Addendum

Iowa Department of Transportation Date of Letting: December 20, 2016

Office of Contracts Date of Addendum: December 14, 2016

B.O.	Proposal ID	Proposal Work Type	County	Project Number	Addendum
111	91-0352-423	PCC Pavement – Grade & Replace	Warren	BRFIMX-035-2(423)4414-91 IMX-035-2(438)4402-91 IMX-035-2(439)4402-91	20dec111a01

SHEET C.2; ESTIMATE REFERENCE INFORMATION:

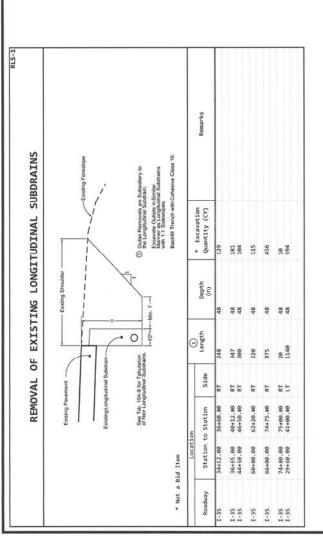
ITEM NO. 97 2502-6745952 REMOVAL OF SUBDRAIN:

Add note 'Refer to Tab. RLS-1 in the CS Sheets for existing lengths and locations.

Method of Measurement: The length of subdrain removed will be measured to the nearest lineal foot.

Basis of Payment: The contractor will be paid the contract unit price for each lineal foot of subdrain removed. Payment shall be for the proper removal and disposal of the longitudinal subdrain. The class 10 excavation and backfill shall be considered incidental to the removal of the longitudinal subdrain.
